Peterson Creek and Aquifer - Review of Ajax Mine Permit 3904 for Reliably Characterizing and Preventing Water Contamination by Existing Mine Wastes

Kamloops Area Preservation Association (KAPA)
Kamloops, British Columbia

Kevin A. Morin, Ph.D., P.Geo., L.Hydrogeo.
Minesite Drainage Assessment Group
A Division of Morwijk Enterprises Ltd.
Surrey, British Columbia
www.MDAG.com

April 15, 2020

Figure 5-5. Map of the deeper groundwater elevations around the old Ajax Minesite, showing groundwater moving towards Peterson Creek and not being captured by the Ajax West pits (adapted from BGC, 2015).

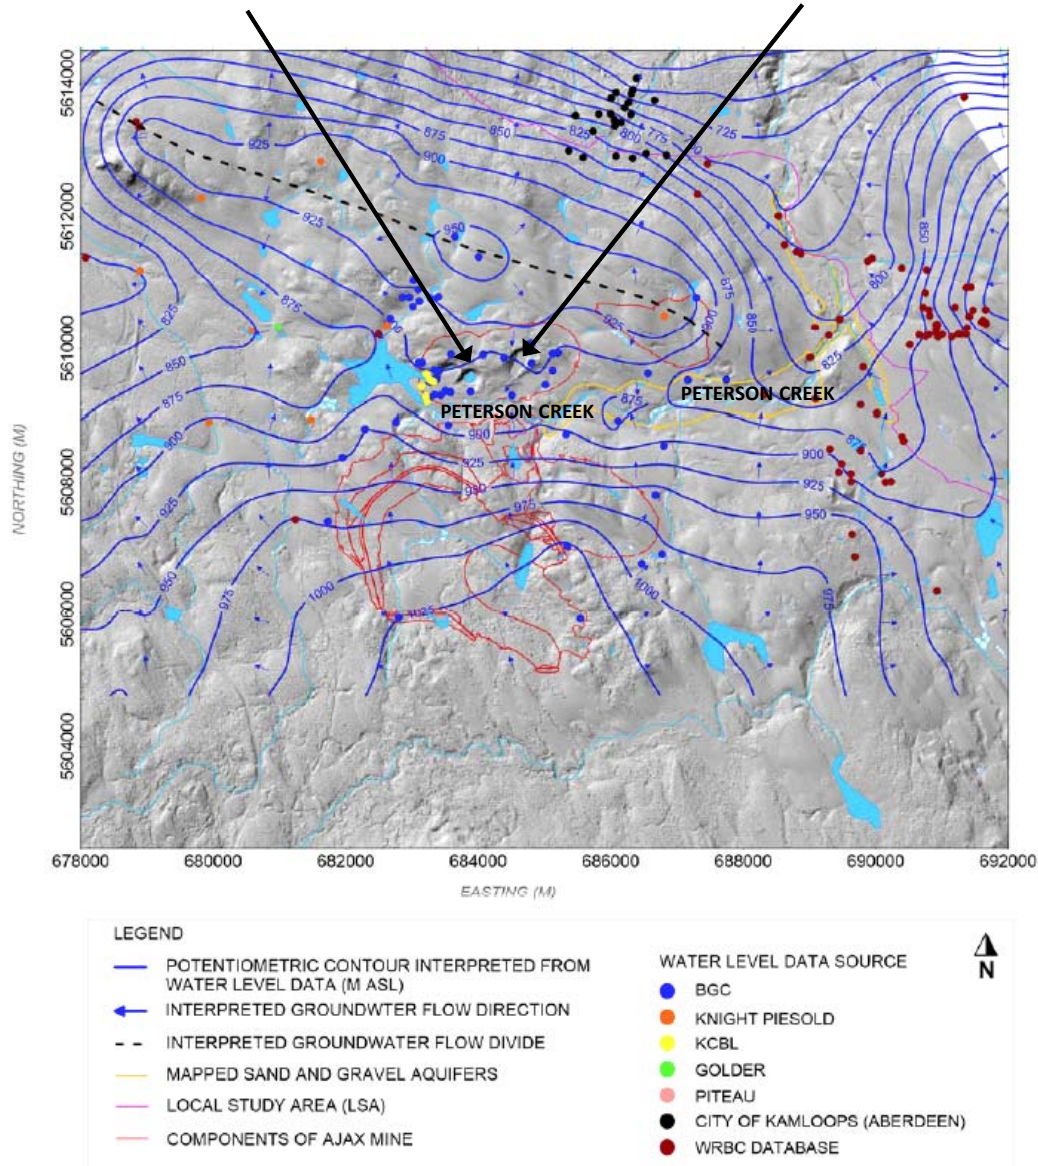
Dozens of monitor wells and piezometers, some measured for groundwater elevation hundreds of times over two years, show these pits have no detectable effect on groundwater flow through the old minesite, at least 150 m outside their perimeters. This applies to both shallow groundwater (Figure 5-4) and deeper groundwater (Figure 5-5).

Figure 5-6. Vertical cross-section through the Ajax West West Pit in the northeast to Peterson Creek in the southwest, showing no significant effect of the West West Pit on groundwater elevations.

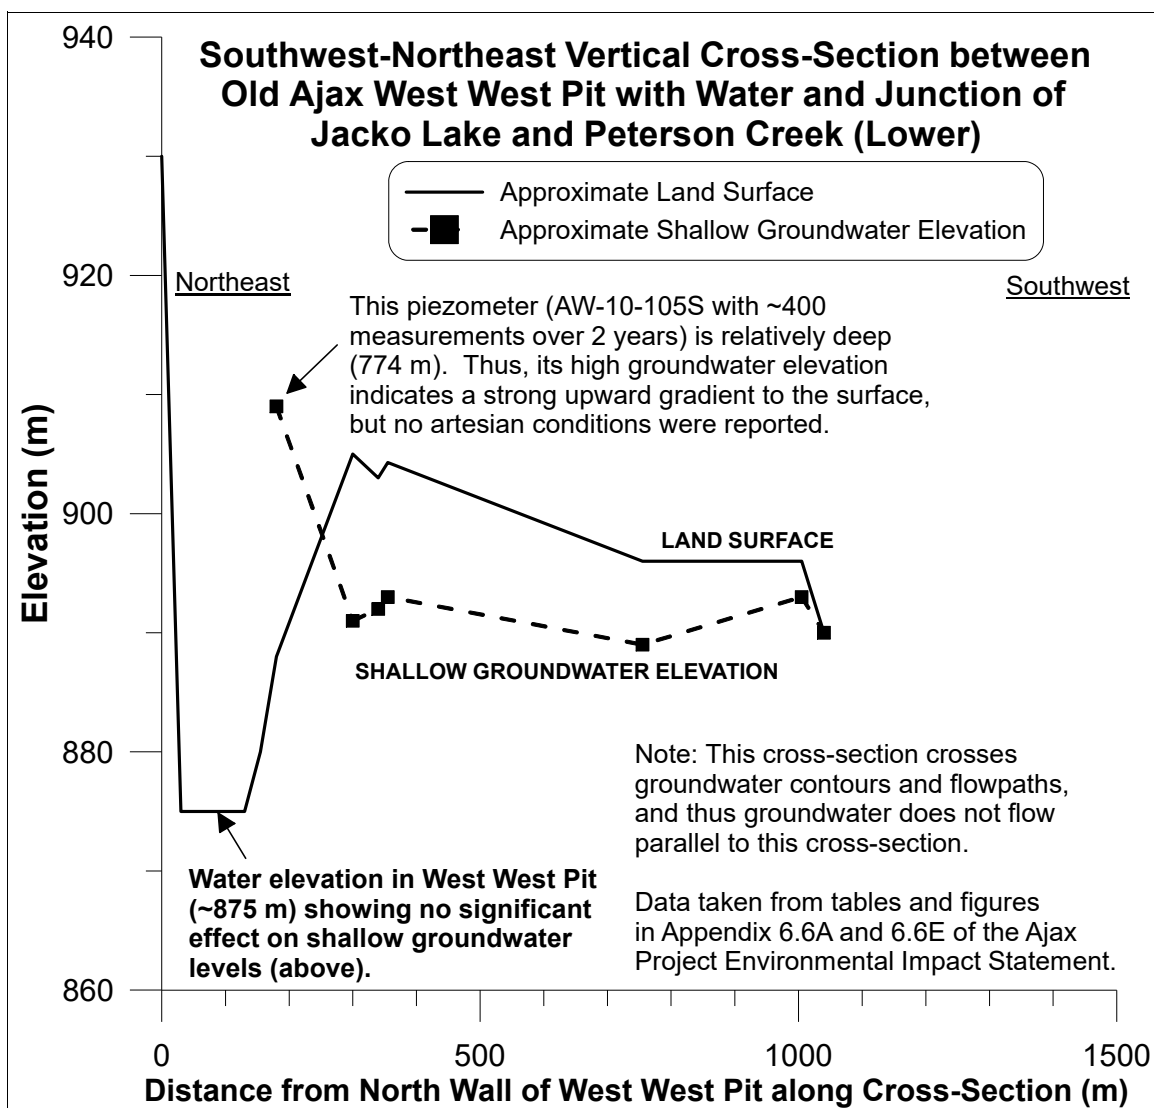
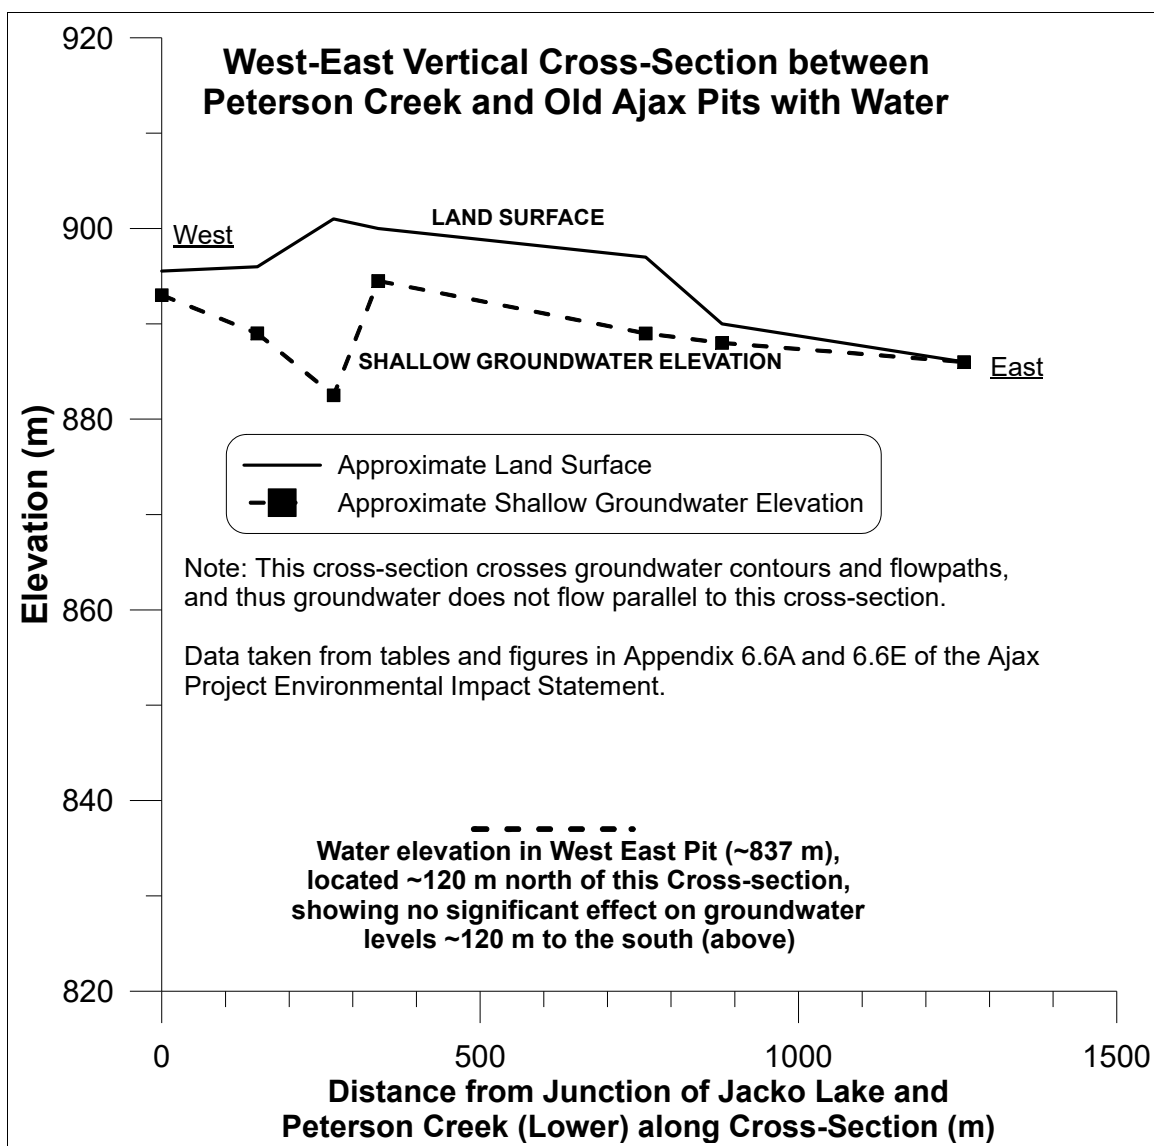
For further evidence of this in this review, groundwater levels were taken from the EIS to create two vertical cross-sections through the old minesite area (Figures 5-6 and 5-7, which are not parallel to flow directions but cut across). These again show no significant effect of the Ajax West pits on groundwater movement through the old Ajax Minesite towards Peterson Creek.
